Subject: McGuire Nuclear Station, Units 1 and 2
Docket Nos. 50-369 and 50-370
Proposed Technical Specification (TS) Amendment
TS 3/4.8.2 - D.C. Sources
Supplemental Information

ATTACHMENT 1

12/28/94 REQUEST FOR ADDITIONAL INFORMATION

Vital Instrumentation and Control Power System

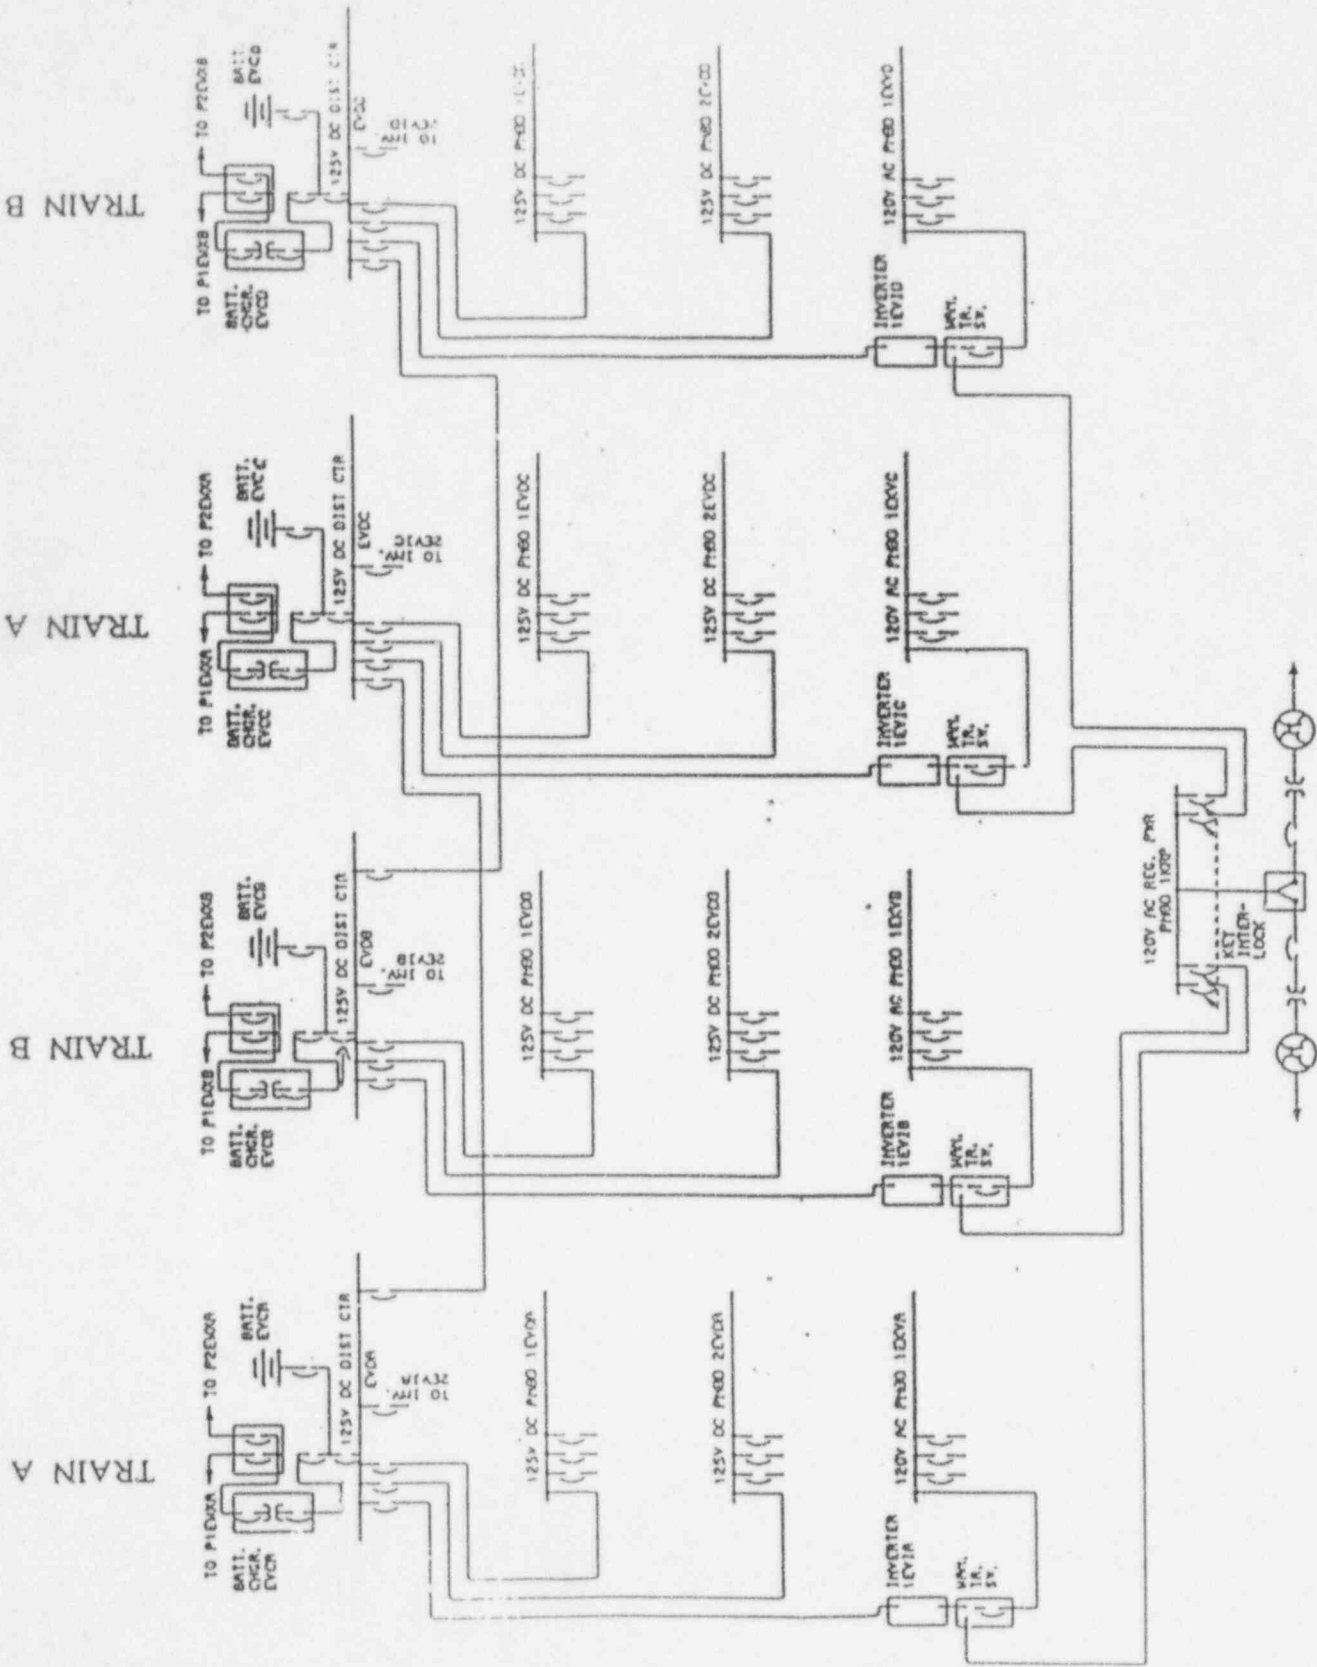
Provide the rationale and justification (deterministic) as to why it is acceptable to perform the battery PDT during the 72-hour AOT in view of the guidance given in Regulatory Guides (RGs) 1.6, "Single Failures" and 1.93, "Availability of Electric Power Sources." Provide justification for one, and two unit operation.

The design of the 125 VDC system is such that four batteries, chargers and distribution centers serve both units (see diagram at end of this attachment). A dedicated battery and charger are connected to each distribution center. Also, a spare charger (not shown on diagram) is normally connected to two same-train distribution centers when they are tied together for removing a battery and its charger for maintenance. This alignment is controlled by approved procedures. Each battery is sized to carry the accident loads of one unit plus the safe shutdown loads of the other unit for a complete train assuming a loss of offsite power. Coordination also exist with the completion of NSM-52428 (scheduled for completion before the upcoming Unit 1 outage) such that a fault at the system level on the non-accident Unit will not affect the ability to supply ESF loads in one Unit and safely shutdown the other Unit, assuming a loss of offsite power.

Distribution centers EVLA and EVDC can be tied together and controlled by approved procedures since they are of the same train (Train A). Likewise, distribution centers EVDB and EVDD can be tied together since they are of the same train (Train B).

When the ACTION statement of TS 3.8.2.1.b.2 is invoked via OPERABLE tie breakers and one battery and charger is removed from a bus (example EVDA bus), this bus and its associated same train bus (EVDC bus) are energized by EVDC battery, battery charger, and spare charger. **Train redundancy is maintained at all times.**
